Reviewer 1:

Comment 1.1: CalMAPLab is a Ford Transit 250 retrofitted as a research-grade mobile air-quality laboratory, built around a strong contemporary instrument payload (Vocus PTR-ToF-MS, dual Aeris Mira Ultras, LI-7200, CAPS, EcoPhysics nCLD, 2BTech O₃, Fidas, AE33, CPC, Spider-MAGIC) and supported by VanDAQ, a custom open-source data acquisition and user interface framework. The vehicle and electrical integration are modern, and with 500+ hours of test driving the platform clearly works as intended. The manuscript has three problems the current draft does not adequately address. The novelty claim does not hold up against an existing literature the authors do not cite. The most distinctive piece of work, VanDAQ, is documented at a depth that does not match its novelty. The hardware description is precise enough to convince a reader the system works but not precise enough to let another group build one.

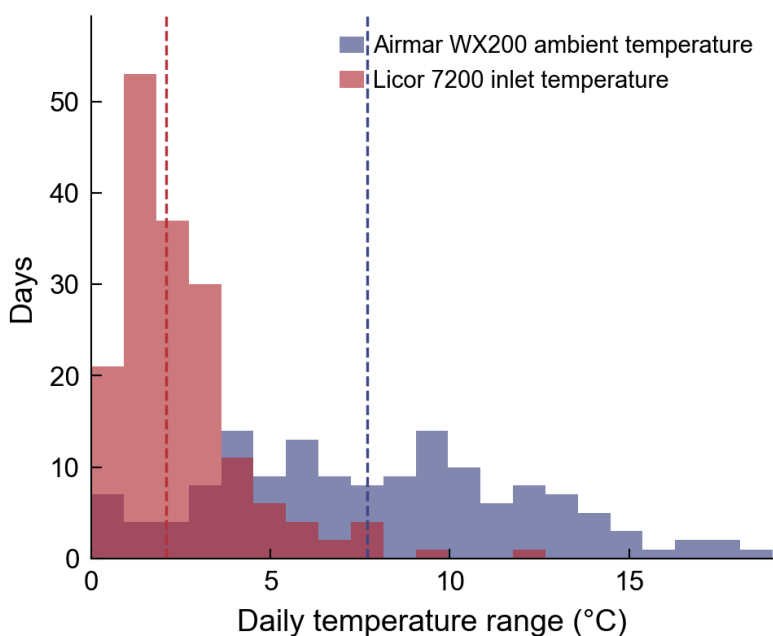
Comment 1.12: The Mira Ultras, CAPS, and Vocus are temperature-sensitive, and the sample lines run between an interior climate-controlled volume and a roof-mounted ambient inlet. The transient thermal response of the lines as the van moves between, say, a 35 °C parking lot and a 12 °C coastal fog bank is not addressed.

Response: We thank the reviewer for raising sample line thermal transients. The inlet draws ambient air into a van maintained at $\geq 23 \text{ °C}$. Analysis of the test dataset showed the median daily roof temperature range as measured by the Airmar weather station was 7.7 °C (min = 0.3 °C, max = 22.4 °C). Sample gas temperature is measured by the Licor 7200 CO₂. In comparison to ambient temperature, the median daily sample gas temperature range during operation was measured as 2.1 °C (min = 0.1 °C, max = 12.4 °C). This indicates a strong thermal buffering relative to roof ambient temperature and consistent sample line temperatures throughout operation. For uncorrected air density-sensitive measurements, biases are estimated at ~1%, rising to ~3 % on the days with the greatest temperature variability. Within our instrument payload, these are largely accounted for through measured cell temperature and subsequent internal corrections.

We also do not experience any condensation issues from sampling close to the dew point temperature. Sample dew point was at least 5 °C below the van internal temperature 100% of the time. However, we do note that should sampling take place in more humid environments, heating the sample line is an important consideration.

This discussion has been added to the Section 3.1 text, and a figure highlighting the sample line thermal buffering has been added to the SI.

“Some atmospheric measurements are sensitive to the density and therefore temperature of the sample gas. To assess thermal transients along the sampling path, we compare roof ambient temperature with sample gas temperatures reported at the cell inlet of the Licor 7200. On average, the median daily temperature range on the roof was 7.7 °C (min = 0.3 °C, max = 22.4 °C) whereas median daily ranges at the Licor was 2.1 °C (min = 0.1 °C, max = 12.4 °C, see Fig. S11 for more detail). These results indicate substantial thermal buffering of sample air relative to roof ambient, consistent with heating and residence time in the climate-controlled cabin rather than directly tracking outdoor temperature. For uncorrected density-sensitive measurements, biases are estimated at ~1% rising to ~3% on the days with greatest temperature variability. Within our instrument payload, these are largely accounted for through measured cell temperature and subsequent internal corrections. In addition, no condensation issues were encountered where sample dew point was at least 5 °C below the van internal temperature 100% of the time. However, we do note that should sampling take place in more humid environments, heating the sample line is an important consideration.”
